Process Change Notification PCN42- 2020

FAB process change TM2703

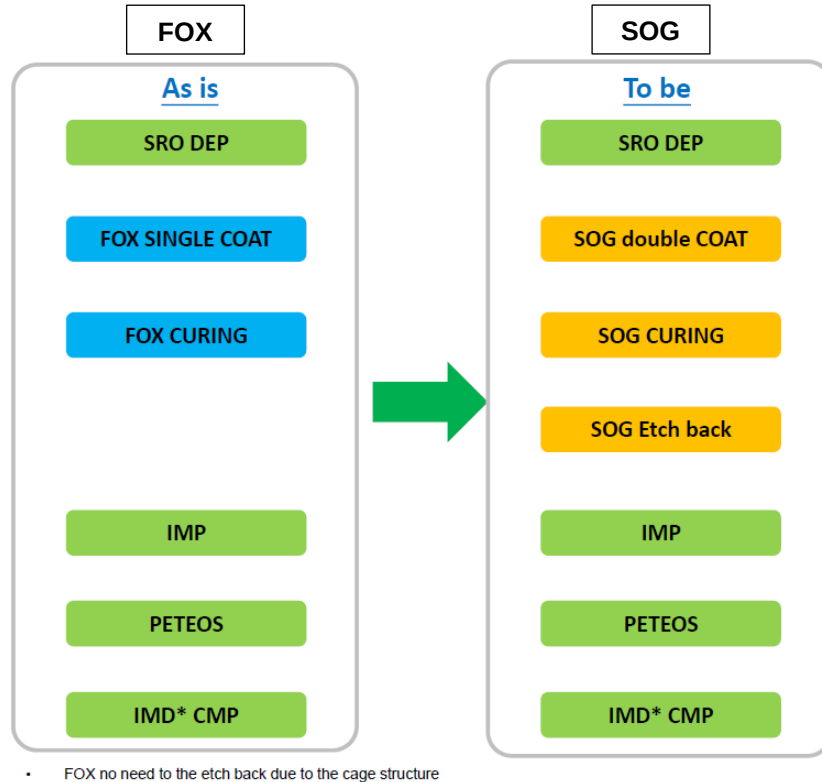
The purpose of this PCN is to notify the customer regarding an upcoming process change for the TM2703 family of device. The current Inter metal dielectric (IMD) process for the TM2703 device uses FOX process and the proposed change will include the change of the IMD process from FOX to SOG process (additional process details included in sec 3). The reason for this proposed change is that UMC is discontinuing the use of FOX material in their process.

The below table shows a process flow comparison of the IMD process.

Proposed Qualification Plan for TM2703 FAB 8AB Material

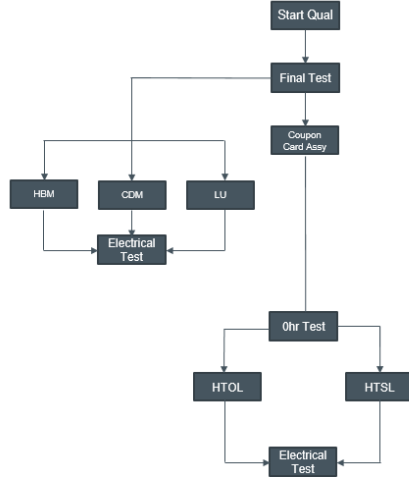
Qualification Plan for TM2703 material with SOG process (TSL25723FN)
